Service Information

Washing machine Toploader

AWE 7515/1

Last Modification: 09/29/10

Service Bulletin 4812 712 40355

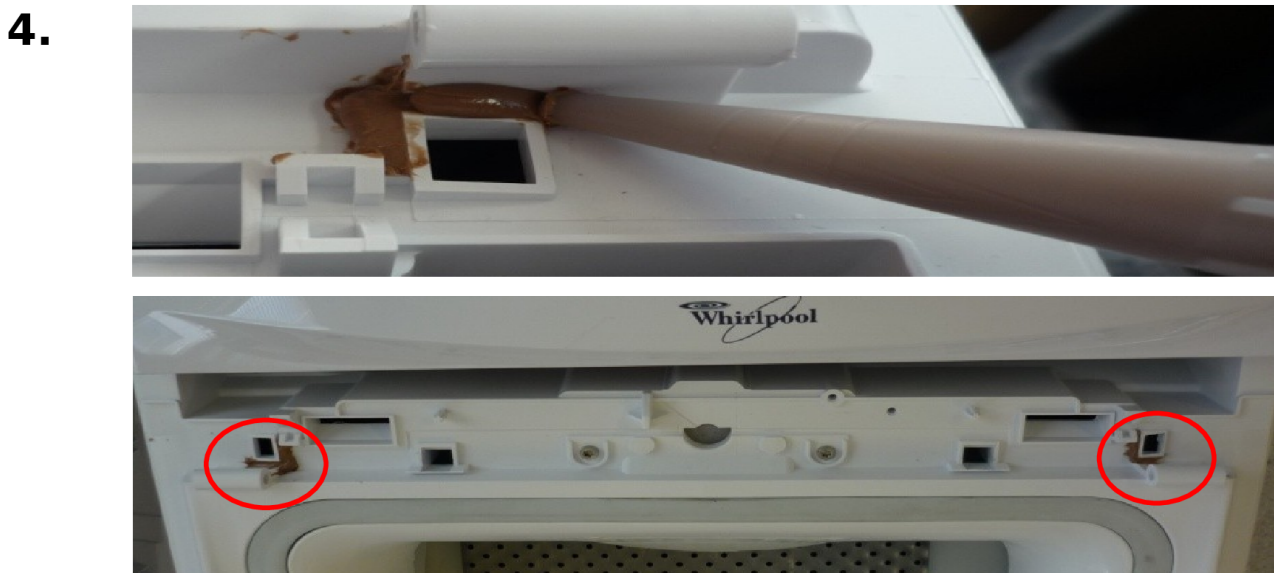
TITLE: Water dripping from lid onto side panels.

SUBJECT: In rare cases, when the lid is opened after a washing cycle, water drips down the side panels.

If customer claims wet side panels, remove the lid and put some silicon in the area of the frame like shown in the pictures.

Clean surface area before sealing

Seal both area surfaces according picture
with white silicon.
